HORSHAM DISTRICT COUNCIL CONSULTATION

TO:	Horsham District Council – Planning Dept
LOCATION:	Development at Rusper Road Horsham West Sussex
DESCRIPTION:	Reserved Matters application pursuant to Condition 5 of Outline Planning Permission reference DC/16/1677 for the Village Centre in RM Area 3 comprising 44 residential dwellings (Use Class C3), 753 sqm (GIA) of flexible retail, leisure, commercial, cafe and restaurant floorspace (Use Classes A1, A2, A3, A4, A5, B1 and D1), plaza, car and cycle parking, landscaping, drainage, access and internal roads and associated infrastructure.
REFERENCE:	DC/25/1018
RE-CONSULT:	1st set of comments in black 2nd set of comments in blue
RECOMMENDATION:	Modification Advice/Modification

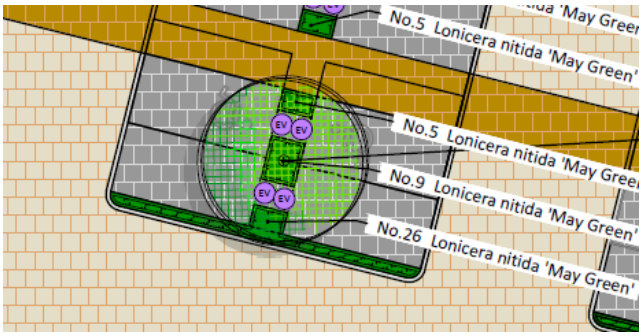
9. Please include a root barrier location for the tree indicated below:
   Closed, with thanks.
